Subject: Waterford 3 SES
Docket No. 50-382
License No. NPF-38
Change No. 1 to the Core Operating
Limits Report for Cycle 11

Change No. 1 to Core Operating Limits Report for Cycle 11

REVISION 0
CHANGE NO. 1

COLR Figure 5

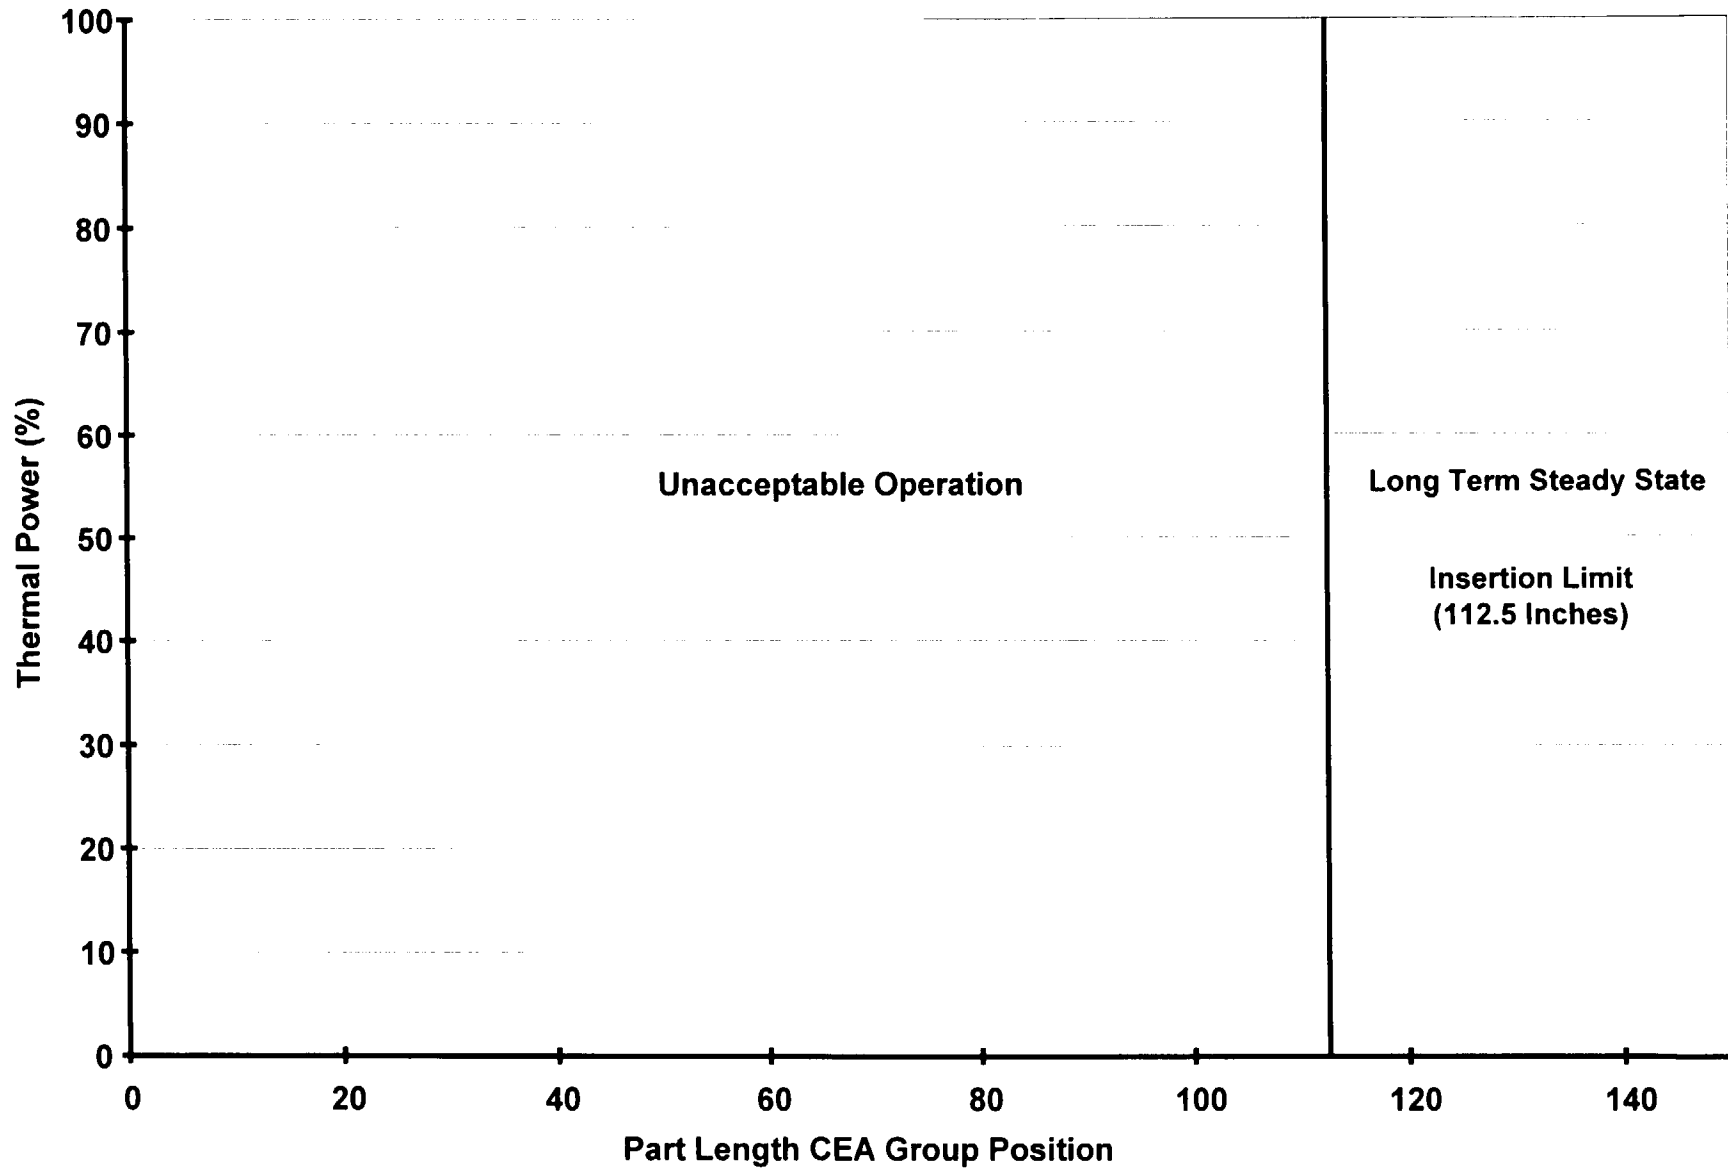
- During RF10, a reduction in total pressurizer heater capacity was identified due to the removal of one heater element and the degradation of three other heaters. Review of the safety analyses for potential impact determined that it was necessary to implement operating restrictions for the beginning part of Cycle 11 to maintain appropriate acceptance criteria. COLR Section 3.1.3.7, Figure 5, has been revised to restrict insertion of the part-length control rods to no more than 25 percent inserted (112.5 inches withdrawn) for all power levels. This restriction and administrative controls will remain in place until the Moderator Temperature Coefficient (MTC) at 0% power becomes more negative than $-0.2 \times 10^{-4} \Delta p/^{\circ}\text{F}$. After that time, the restriction will be removed and COLR Figure 5 will be revised back to the original limits.

In accordance with the 50.59 Evaluation #00-068 for ER-W3-00-0853-00-00, Replacement of Pressurizer Proportional Heaters, Section 3.1.3.7 COLR Figure 5 was revised to restrict the part-length rods to 25 percent inserted (112.5 inches withdrawn) for all power levels until the Moderator Temperature Coefficient (MTC) at 50% power and below is confirmed to be more negative than the limits presented in the table below. This restriction will apply to power levels below 20% because the thermal margin requirements at 20% are used to define and bound those at lower powers. Technical Specifications (TS) 3.1.3.7, Part Length CEA Insertion Limits, is only applicable in Mode 1 above 20% thermal power. However, during Cycle 11 while the restriction is required, administrative controls will be employed to ensure the new COLR Figure is applied at all power levels.

Power level, % of rated			
	0	20	50	70
MTC limits above which PLR restriction and BERR1 penalty apply, ($\times 10^{-4} \Delta\rho/^\circ\text{F}$)	-0.2	-0.2	-0.5	-0.7

COMMITMENT(S)	ONE-TIME ACTION*	CONTINUING COMPLIANCE*	SCHEDULED COMPLETION DATE (IF REQUIRED)	ASSOCIATED CR OR ER
COLR Section 3.1.3.7, Figure 5, has been revised to restrict insertion of the part-length control rods to no more than 25 percent inserted (112.5 inches withdrawn) for all power levels. This restriction will remain in place until the Moderator Temperature and administrative controls Coefficient (MTC) at 0% power becomes more negative than $-0.2 \times 10^{-4} \Delta\rho/^\circ\text{F}$. After that time, the restriction will be removed and COLR Figure 5 will be revised back to the original limits.		X	Initiated operating restriction 11/3/00 Scheduled removal of restriction after a burnup of approx. 172 EFPD in Cycle 11 or approximately 6/27/00	CR-WF3-2000-1362 ER-W3-00-0853-00-00 Commitment P-26059
